工程指示 / 要求簡箋(E.I.)

工程指示編號：EI / 5466 / 22

工程名稱：將軍澳日出康城 11

工程項目：幕牆 單元件修改方案

生母企 梗墙位去水孔+氣孔

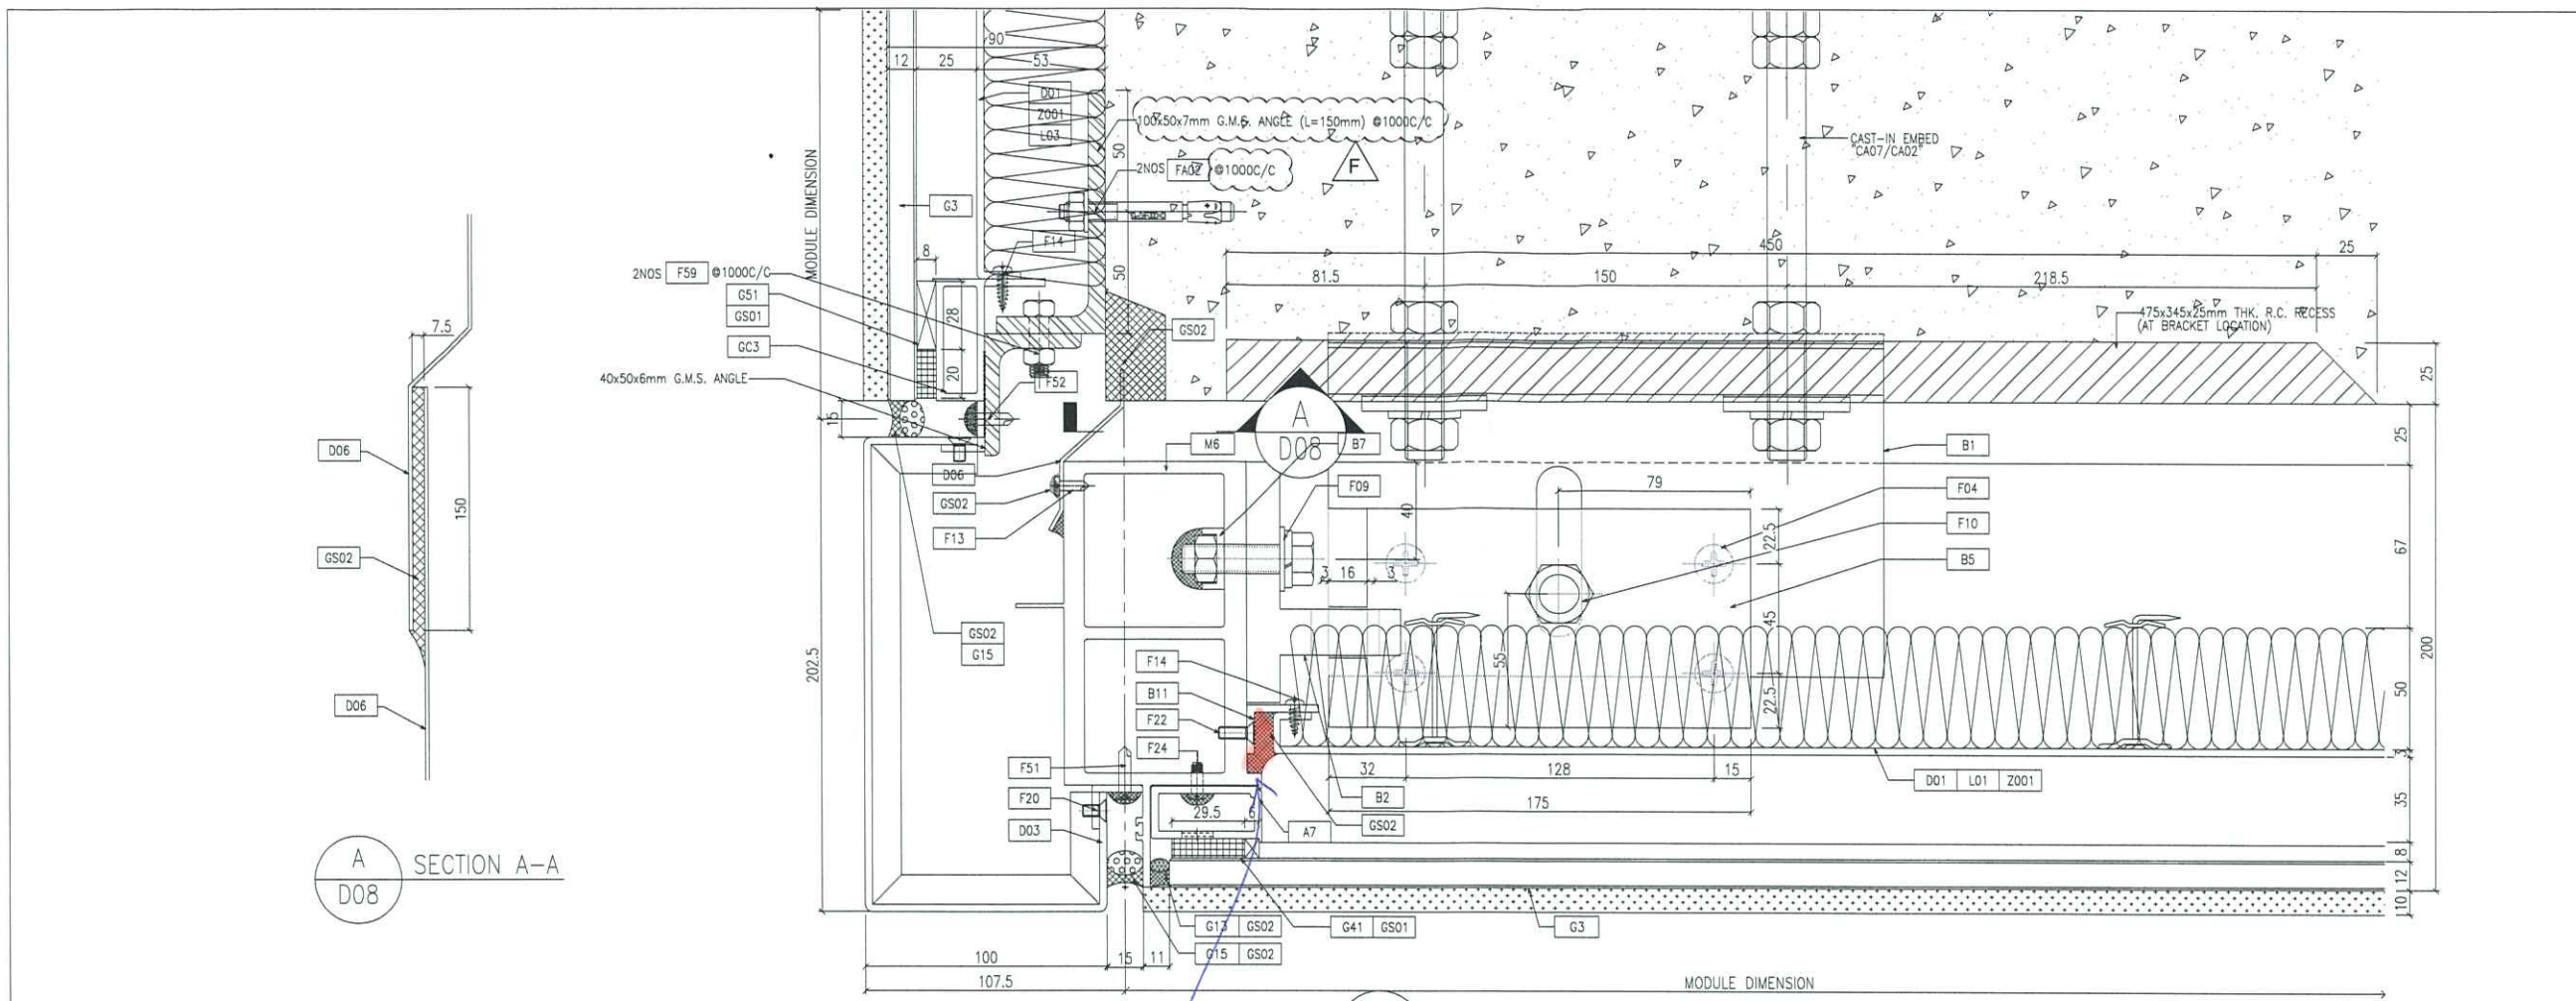
A孔在橫梁頂部，比水槽凹槽要高
水無法從這裡排出

建議將生公企排水孔
改到粗紅線內平齊

經胡哥及琅建議，請按此修改排水孔。

1 TYPICAL MULLION DETAIL
D08 CURTAIN WALL OUTSIDE

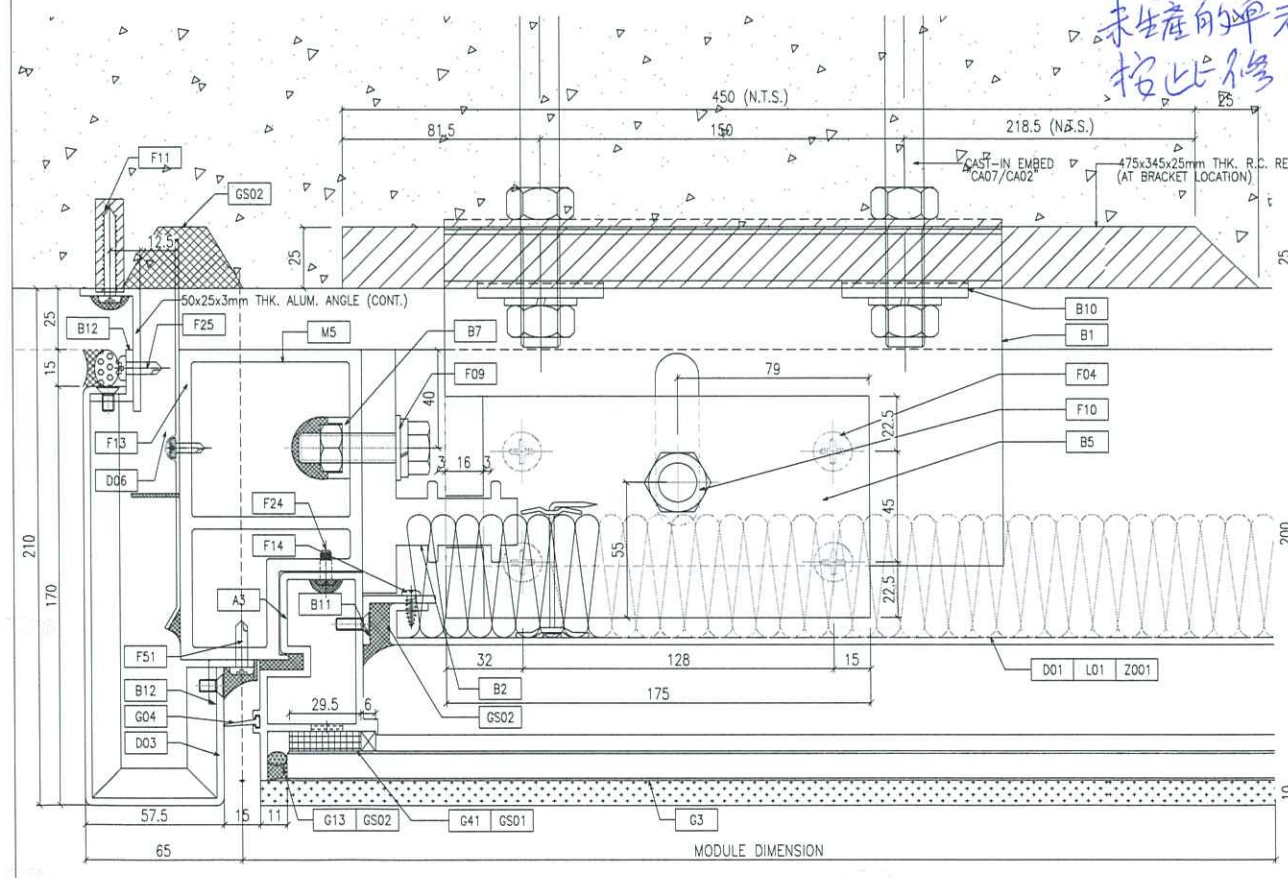
C 版:1.經胡哥及王良建議，需修改排氣孔做法，詳情請見後頁;2.未生產的單元，請按後頁修改唧膠背板方法。B 版: 現確認氣孔做法，詳情請查閱後頁。**A 版:**1.因單元幕牆雙裝飾條那款，主企(X86273-12 等)與玻璃骨(X86305-02 等)的安裝孔尺寸有偏差，導致需要安裝人員自行配孔才能完成安裝，請廠的拆圖部幫忙檢查此類加工圖並修正過來，以便後續的生產能順暢，詳情請見後頁2.夾巴位置由 18.5 改為 20.5;3.轉角窗玉不能開關，需重新拆圖;請在單元件做出以下修改，方便單元件排水:1.扣蓋避位取消(橫向)2.加開避位(企向)3.加開氣孔詳情請見後頁，謝謝!請在 2022.12.15 前完成上列要求。

2 TYPICAL MULLION DETAIL
D08 CURTAIN WALL OUTSIDE

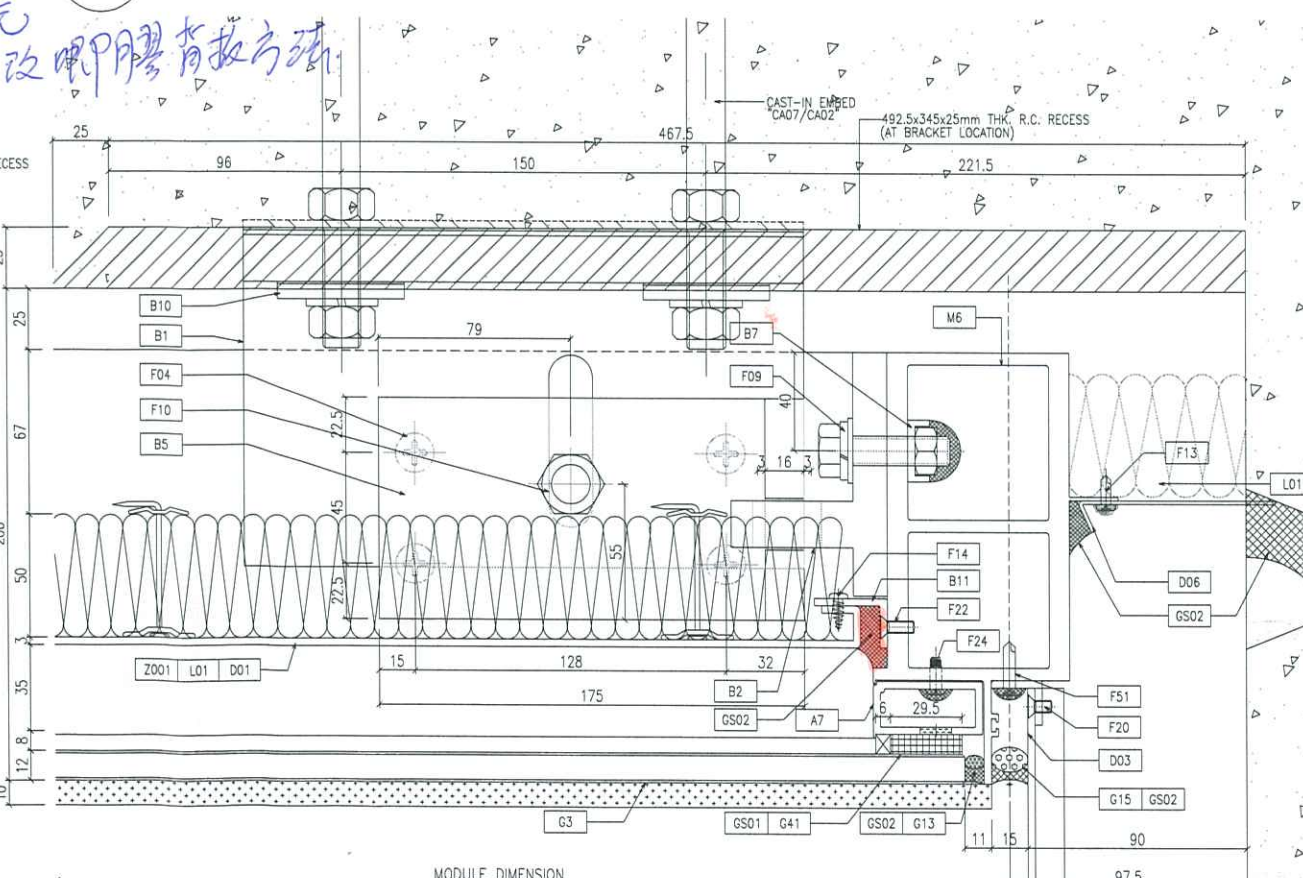
未生產的單元
招此修改膠膠背板方法
